RE: Woodbury Apartments
Tract 17 Bulk Land Plat Tracts 1 through 18 Artiste, Mesa del Sol
Grading and Drainage Plan
Engineer's Stamp Date: 2/22/2024
Hydrology File: R16D097C

Based upon the information provided in your submittal received 2/23/2024, the Grading and Drainage Plan is approved for Building Foundation Permit.

Project Title: Woodbury Apartments at Mesa Del Sol Hydrology File # R16D097C

C801

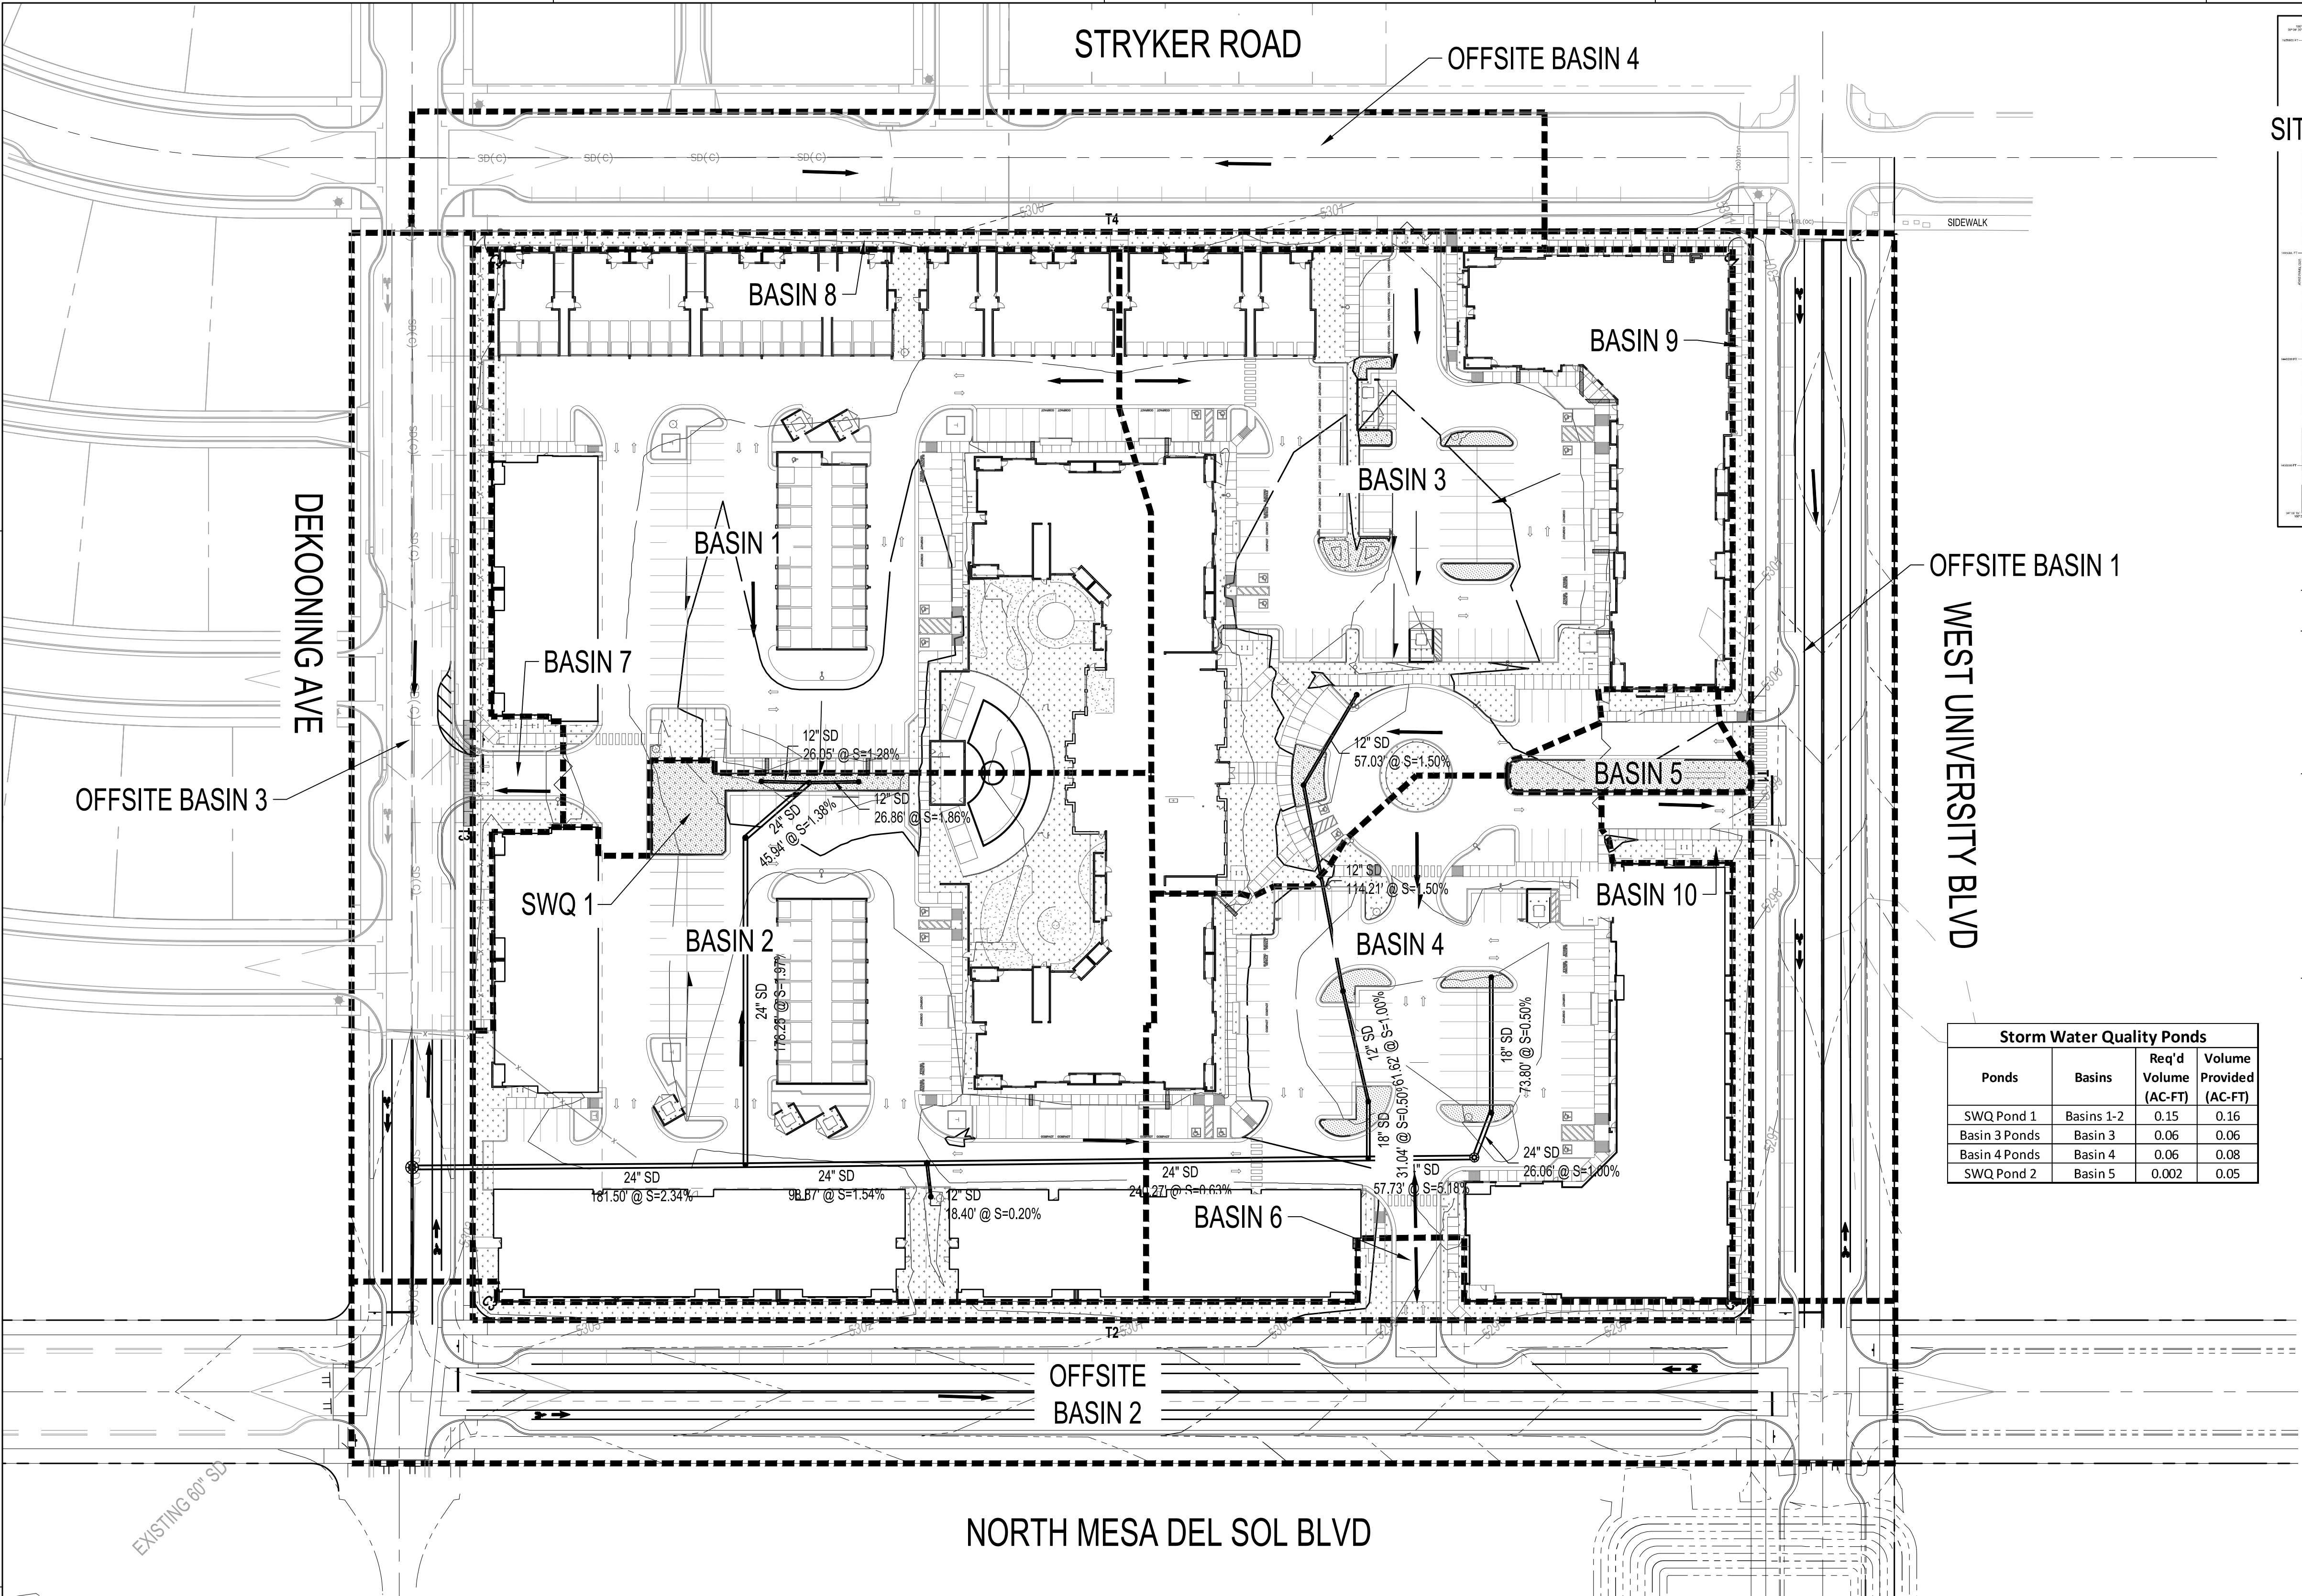
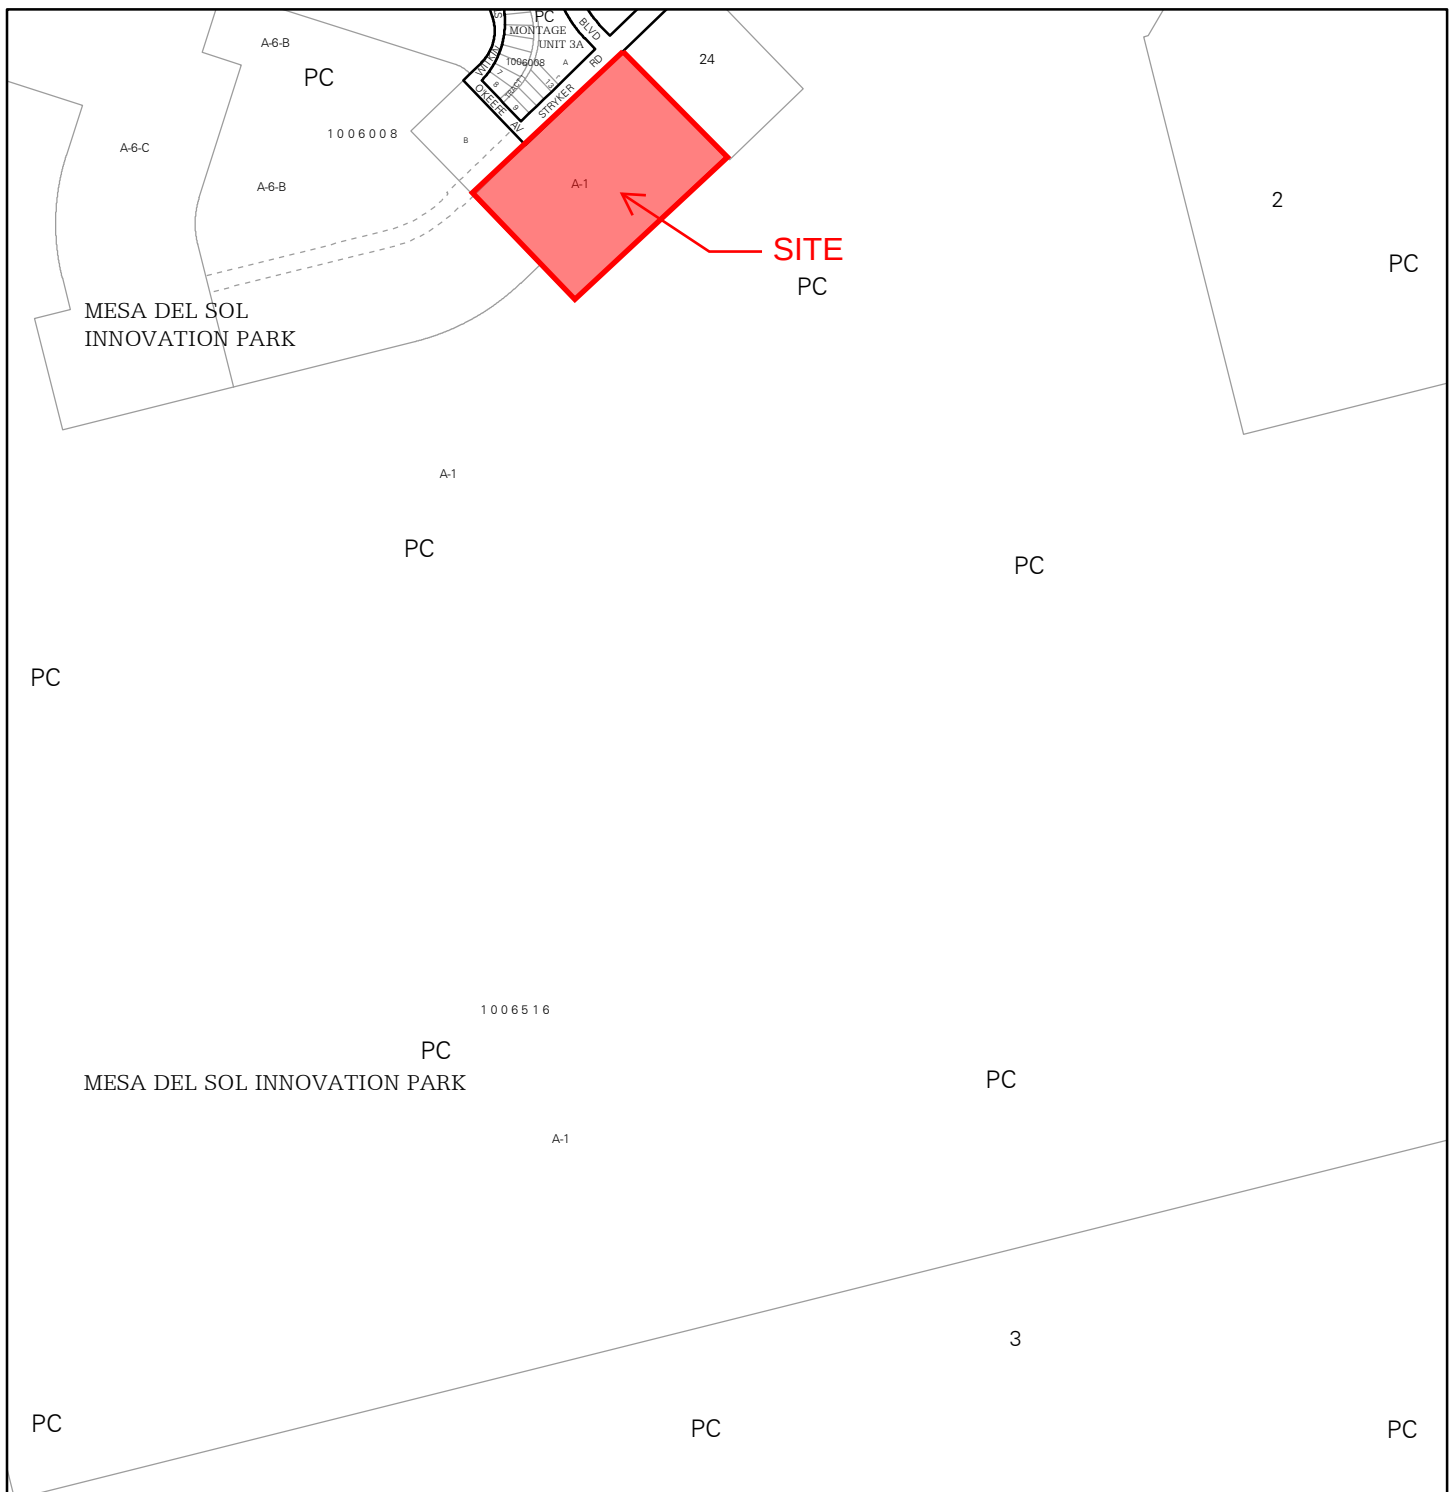
1. Please submit detailed Grading & Drainage Plan to Hydrology for review and approval.
2. Verify the required & provided SWQ volumes for Basin 3 pond. It shows 0.06 ac-ft in the Storm Water Quality Ponds Table, but 0.065 ac-ft in the Proposed Conditions Basin Data Table on the same sheet (sheet C801).

0.065
ac-ft?
